Vogtle Electric Generating Plant Units 1 and 2
Request for Technical Specifications Changes
VANTAGE-5 Fuel Design

VOGTLE ELECTRIC GENERATING PLANT REQUEST FOR TECHNICAL SPECIFICATIONS CHANGES VANTAGE-5 FUEL DESIGN

BASIS FOR PROPOSED CHANGES

FIGURE 2.1-1
REACTOR CORE SAFETY LIMIT - UNIT 1

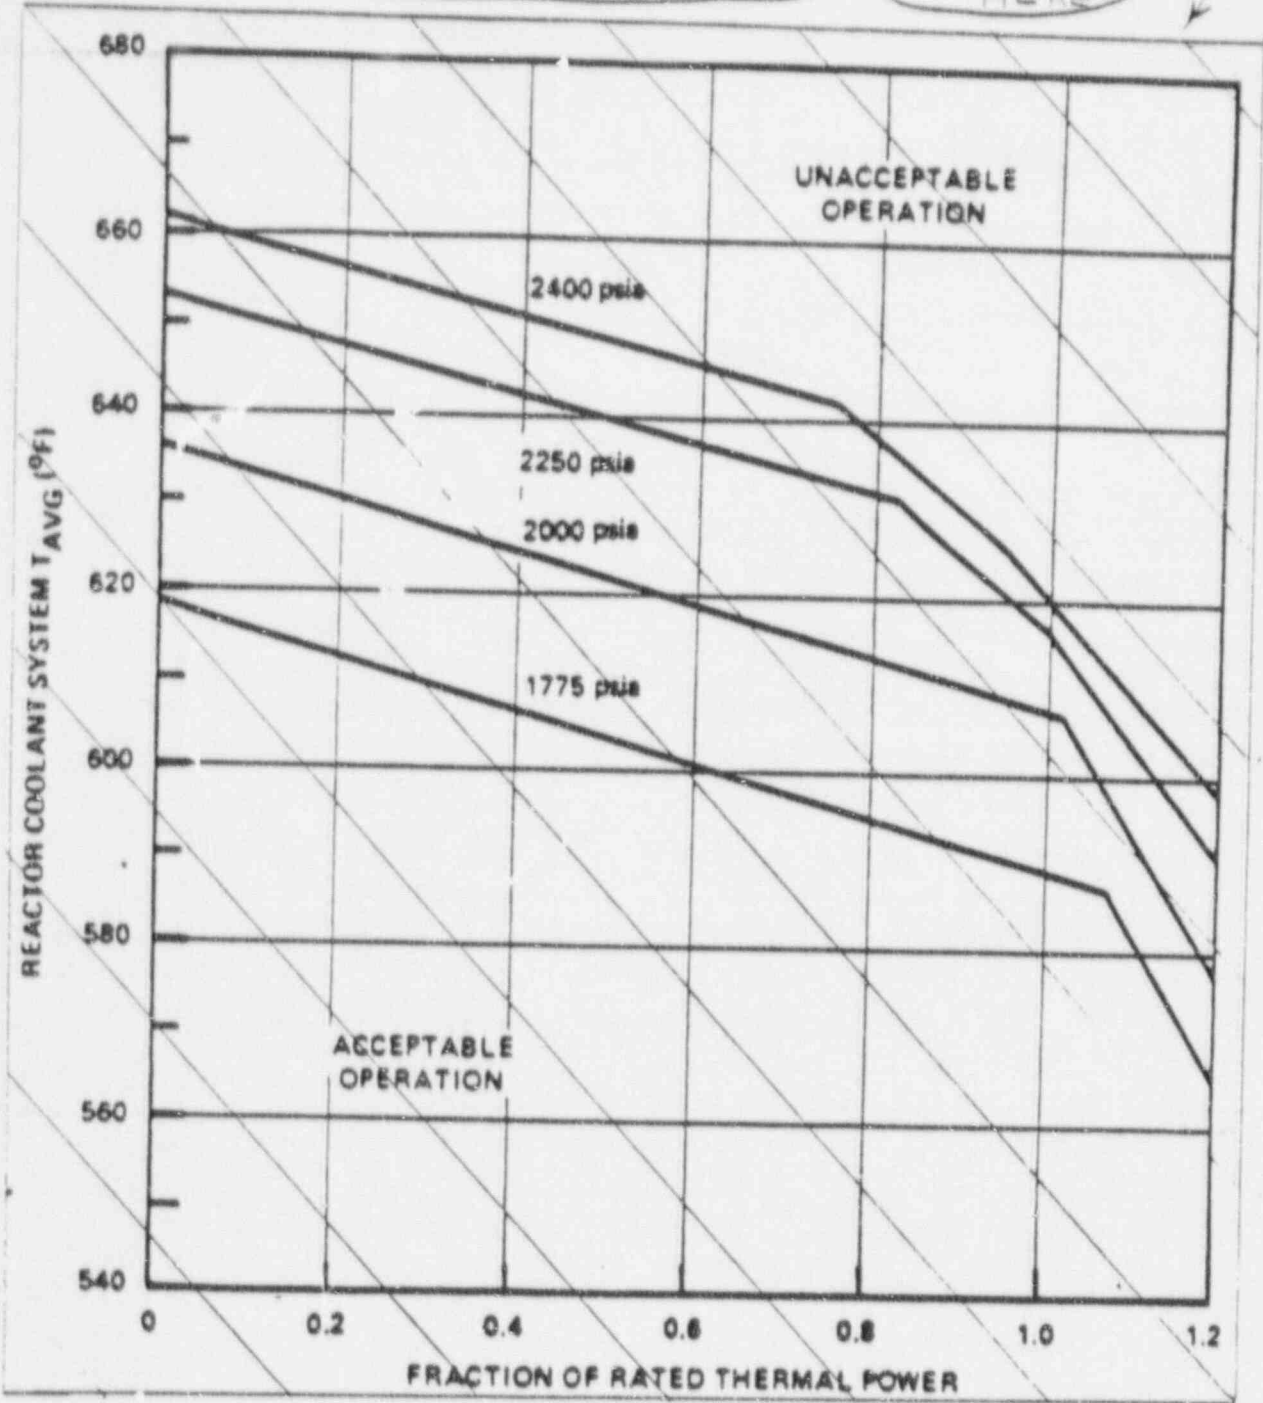
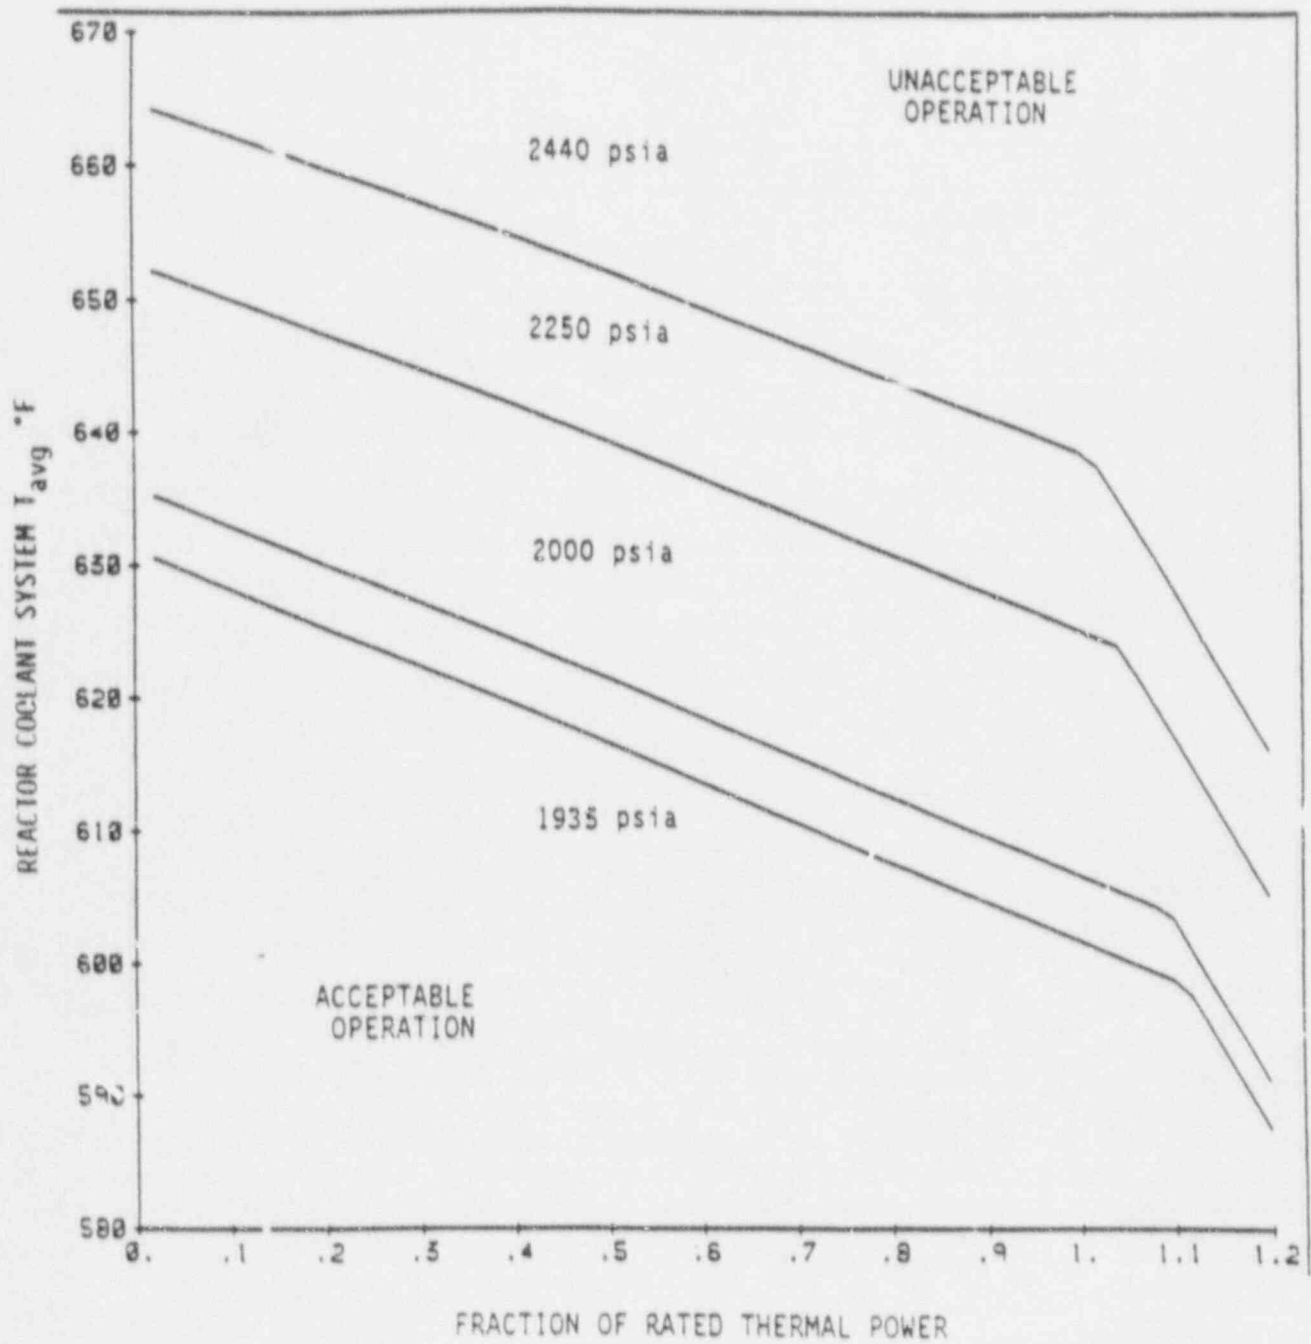
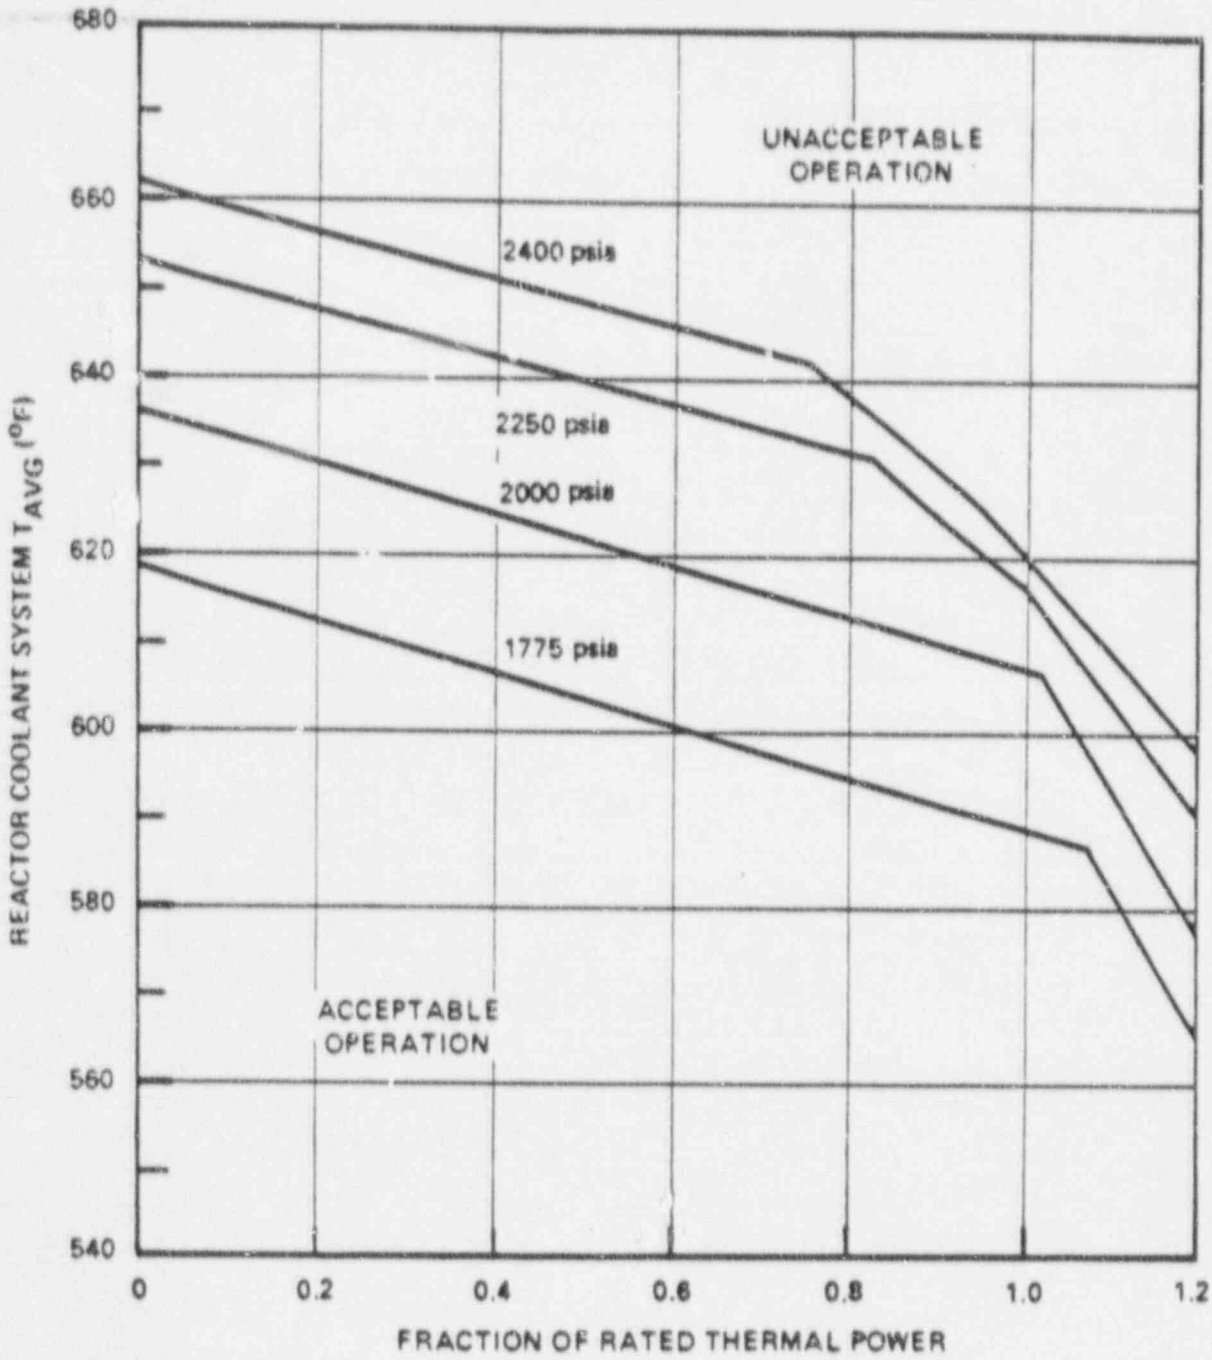
The Technical Specifications changes for the core safety limits and over-temperature delta-T and over-power delta-T setpoints (Technical Specifications 2.1 and 2.2) were changed as a result of using DNB margin gained through the use of the VANTAGE-5 IFM grid feature, improved THINC-IV code, WRB-1 and WRB-2 DNB correlation, and RTDP. BART/BASH, NOTRUMP, and RAOC implementation were also factored into these Technical Specifications changes. The Technical Specifications core limits and setpoints changes accommodate the use of higher peaking factors for F-delta-H and F_Q, deletion of thimble plugs, axial blankets, IFBAs, the VANTAGE-5 rod and lattice geometry, higher steam generator tube plugging, mixed fuel type core DNB and LOCA peak clad temperature transition penalties, and future power rerate changes. The higher peaking factors will be revised through the use of the Core Operating Limits Report (COLR).

INSERT 7
HERE

INSERT 7

FIGURE B 3/4 2-1
TYPICAL INDICATED AXIAL FLUX DIFFERENCE VERSUS THERMAL POWER

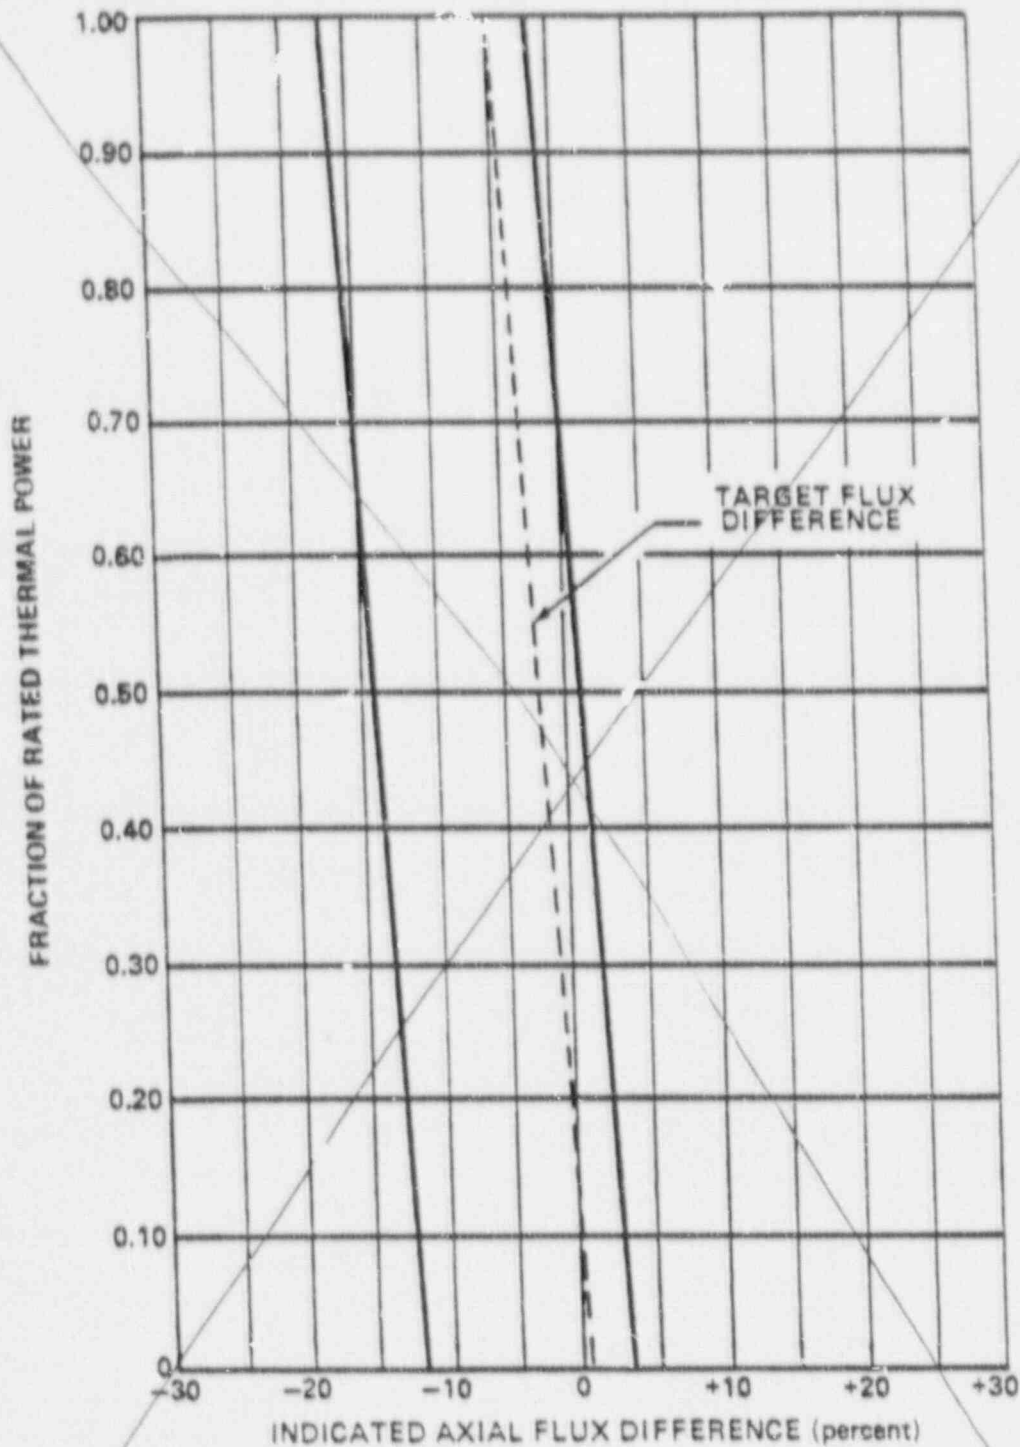
DELETED FOR
UNIT 1 ONLY
